Preliminary Report on the New Hamburg Arena

September 10, 2024

1.0 Introduction

Appendix B: New Hamburg Arena Structural Condition Assessment

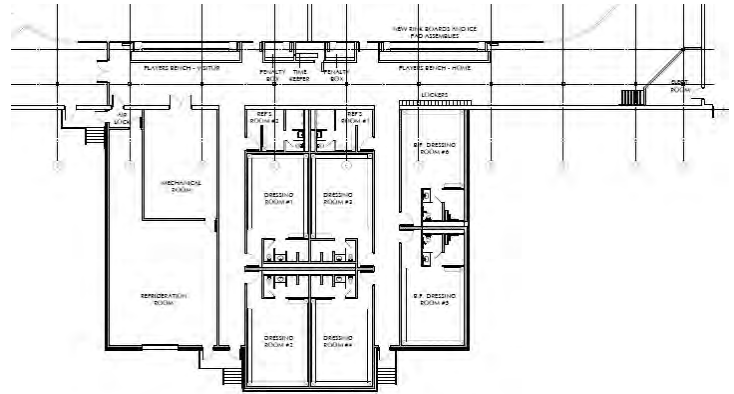
- This report is surprisingly (for the age of the building) positive, and provides a good case for repurposing this facility.
- The arena proper structure is also given a good grade,

- The items listed throughout are minor in nature and most of the issues appear to be with water runoff from the various roofs (not structural).
- There are, however, 2 concerns with this assessment:

1. Mentioned a few times is “a large crack” on the west side of the building that is described aesthetically but not addressed in structural context i.e. is this a structural concern or cosmetic issue? This should have been clarified in the report and if at all possible have the author clarify this now.

2. There are descriptions of “tele-posts” in the basement along with a comment stating the consulting firm is unclear of their purpose but again does not speak to them in a structural context. i.e. are they required? Can they be removed? This could become an important issue with any significant redesigns being considered. We would recommend having the author clarify this as well.

Item 3. Stage 1-2 Archaeological Assessment Part of 251 Jacob Street, New Hamburg

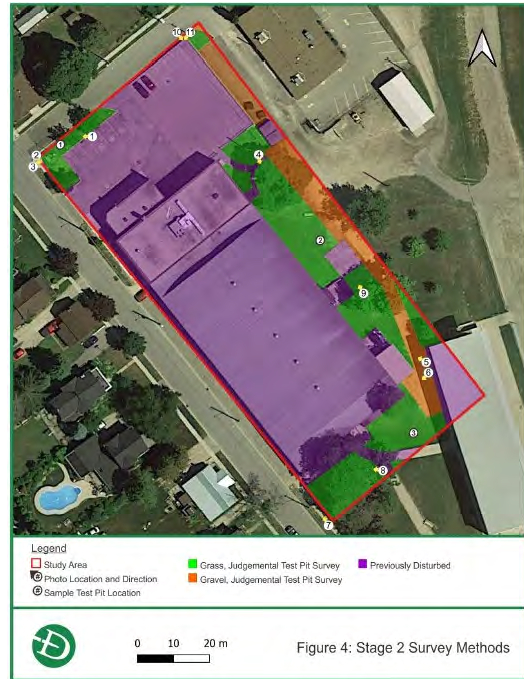
The Executive Summary/Analysis and Conclusions sections both describe an initial Stage 1 background research that indicated the Study Area exhibiting moderate to high potential for the identification and recovery of archaeological resources. However, a subsequent Stage 2 Field Assessment was then completed for a study area (shown in Section 8.0 Maps) representing the extents of any possibility for future development. The Executive Summary describes the Stage 2 investigation resulted in the identification of no archaeological material; therefore, no further archaeological assessment of the Study Area was recommended. It does caution that any portion of the Assessment Property not included within the current Study Area and impacted by development will again require another Stage 1 archaeological assessment. Our future Schematic Design will respect this requirement and avoid development outside the study area unless necessary.

Item 6. Township of Wilmot Building Department Comments & Item 13. Township of Wilmot Fire Department Clarification

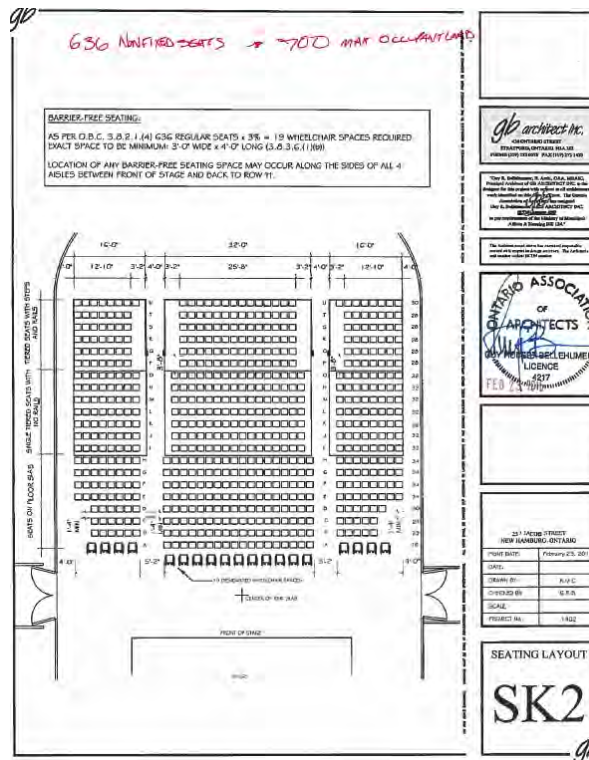
Initially we were provided with item 5. which we believe indicated the Local Building Departments approval of the Community Players of New Hamburg proposed seating application (Layout and Occupant Load, Arena Floor Stage) in January of 2020 for floor stage shows. However, this was clarified with item 13, where the Township’s Fire Department advised that the 2020 application was never approved and provided a previous 2016 application for the same that was approved. They also confirmed the 2016 application remains the only approved seating layout for stage shows. This 2016 application also indicates provision of permanently installed supplemental exhaust and a deluge sprinkler addition above the stage curtain location.

Item 14. New Hamburg Arena Roof Truss Information

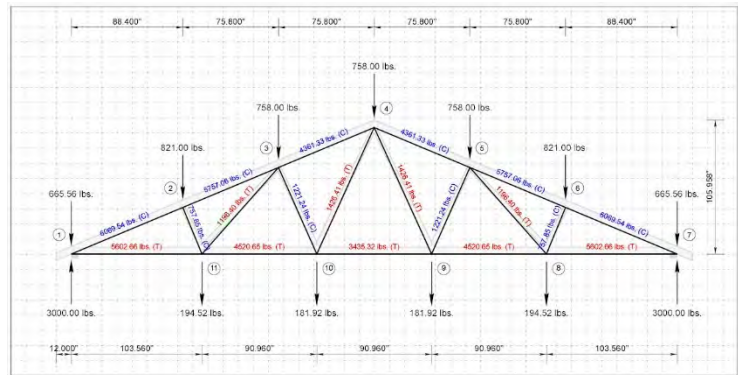
While no drawings are provided with this package, we presume this explains the extra steel columns installed behind the dasher boards at both ends of the ice surface and a number of other observed structural modifications that do not appear to be from the original construction.

During our site visit we measured the existing ice surface size as 79.741'Wide x 180'Long. The Township's current funding application (item 1) requires provision of both a new ice rink slab and surrounding dasher boards. This would have provided an opportunity to investigate expanding the ice surface to National Hockey League (NHL) requirements of 85'Wide by x200'Long which would present a number of additional marketing opportunities to the Township. However, the presence of the extra steel columns installed with these truss modifications makes further lengthening of the ice surface to the 200' NHL requirements or even that of a standard recreations ice surface size of 85'Wide x 185'Long infeasible.
